DESIGN REVIEW & PRESERVATION BOARD

LOCATION: 507 13th Street

PROPOSAL: Addition at the rear of a 3 unit residential structure listed on the Official Register as a Priority Structure.

STAFF EVALUATION: Staff has the following comments and concerns:

UPPER FLOOR PLAN

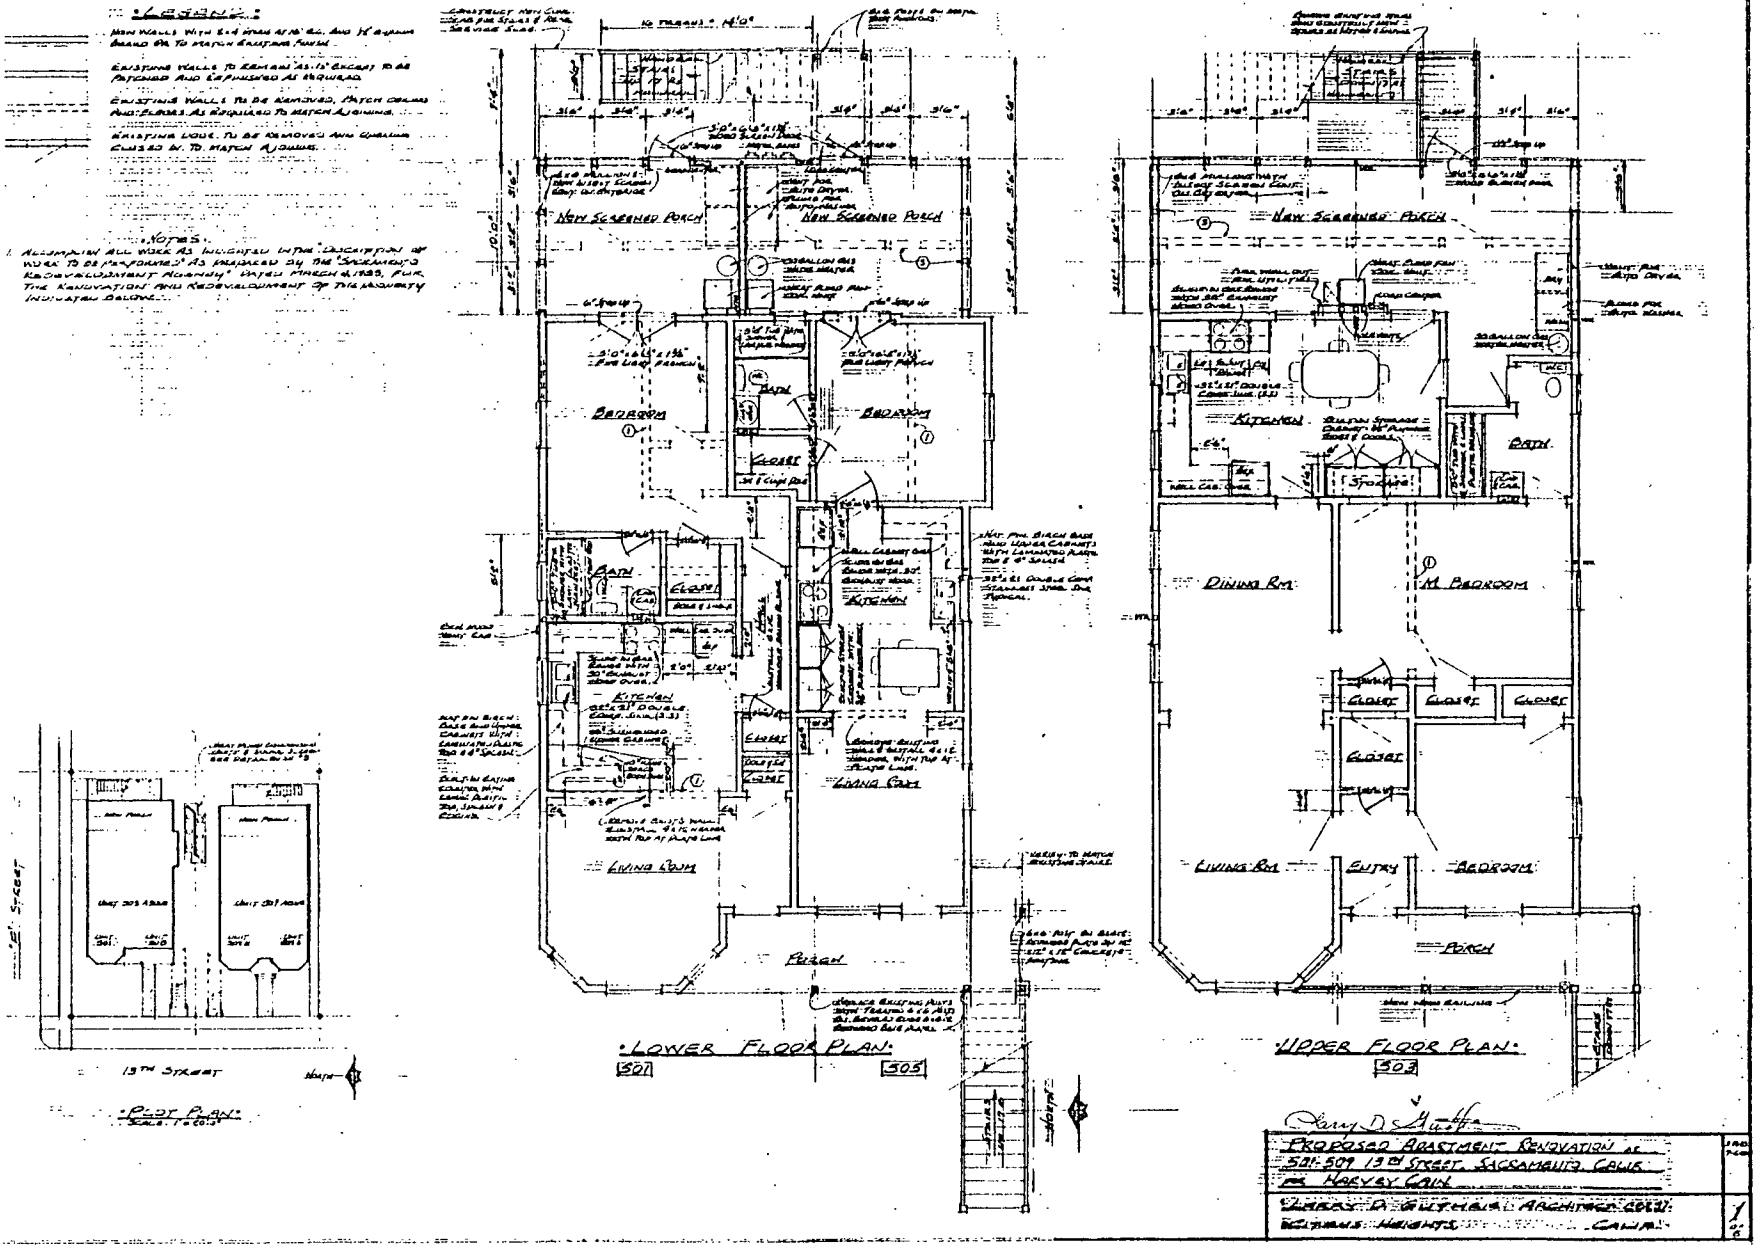
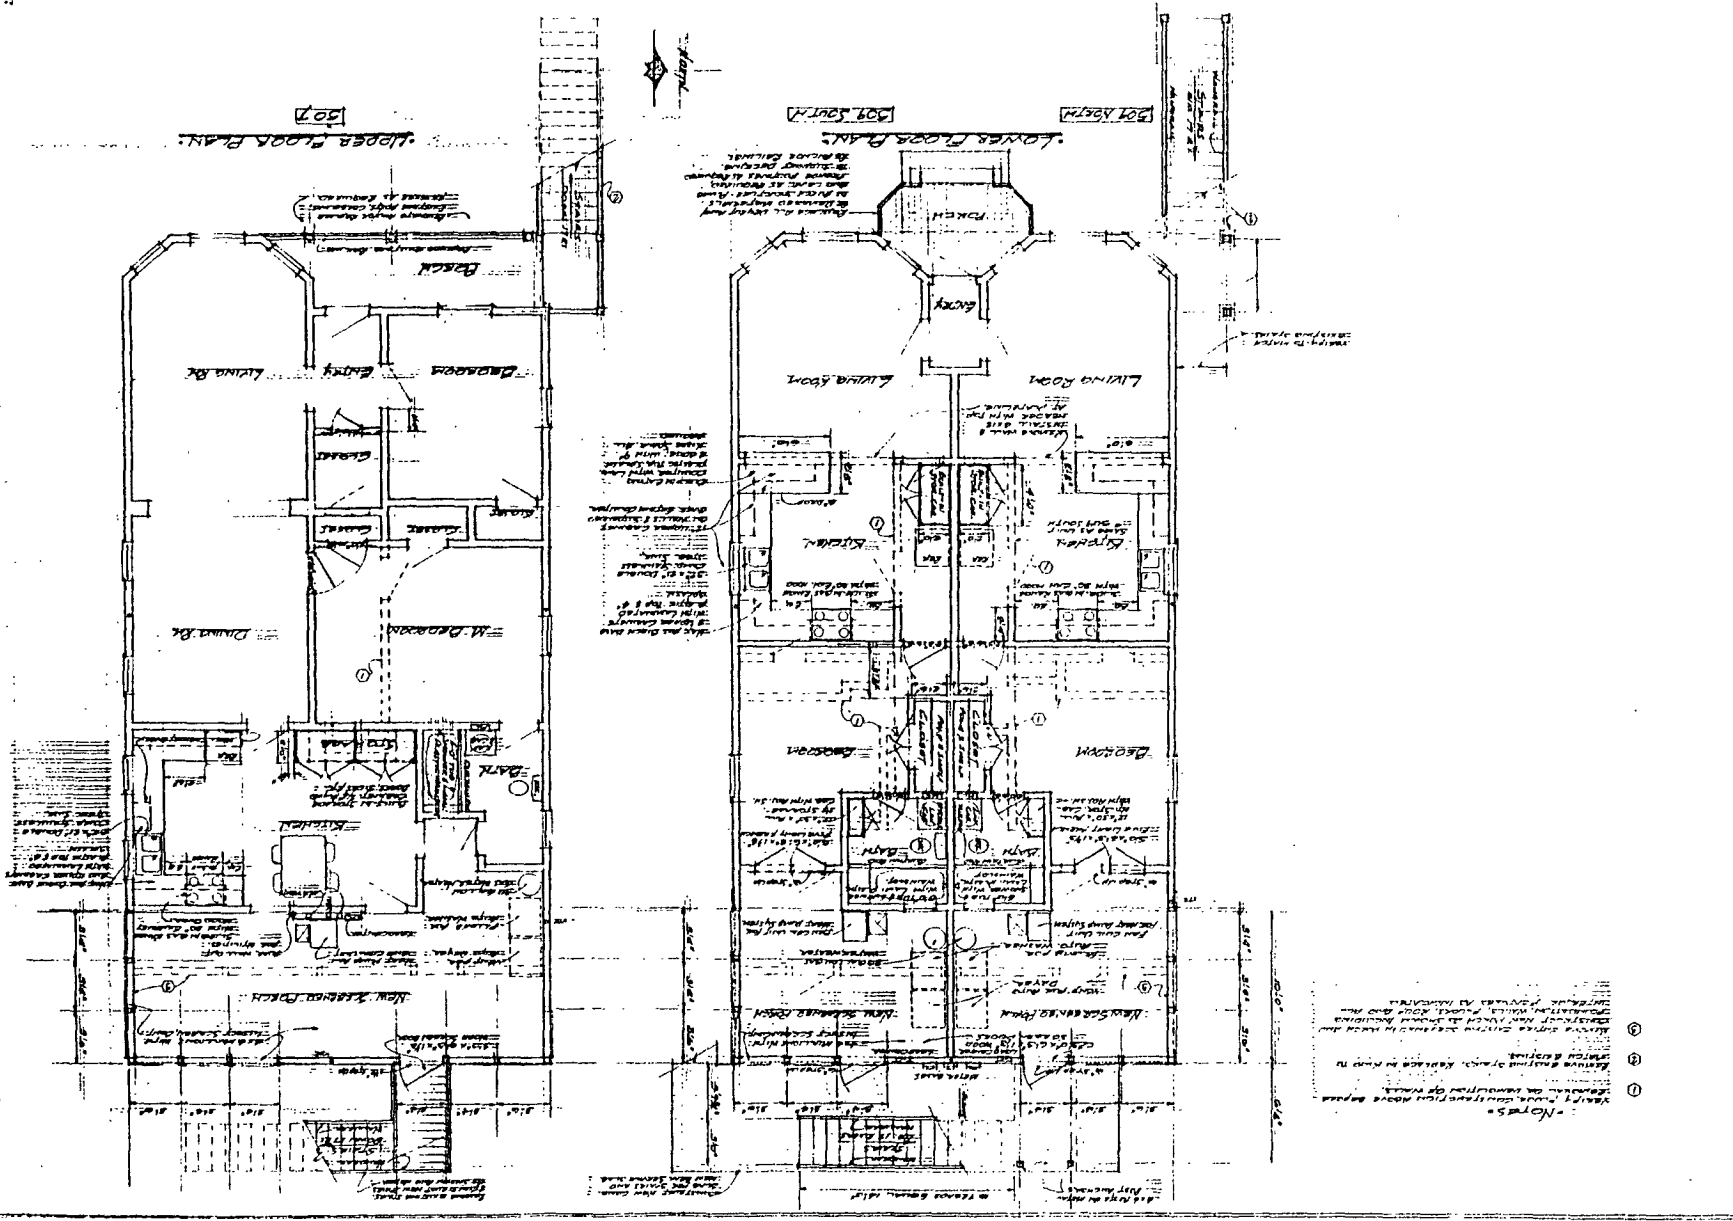
1. Proposed interior modifications and enlargement of the screened porches are intended to improve the livability of the units. Nevertheless, the addition will increase the prominence of the least attractive element of the structure's exterior.

2. Presently the rear porches detract from the aesthetics of the Priority Structure to the east (1310-12 E Street). The addition will do further aesthetic harm to the adjacent structure.

4. Should, however, the Commission approve the variance request and the Board approve the addition, staff suggests that:
 - a. The stairs be set against the face of the addition in order to minimize the degree of encroachment toward the rear and the adjacent Priority Structure.

- b. The color of the building should not be white. A less reflective color that is also compatible with the structure at the rear should be used.
 - c. Horizontal siding matching the main structure shall be used.

- d. Dilapidated fencing shall be replaced.
 - e. Revised plans shall be submitted for review and approval of the Board.
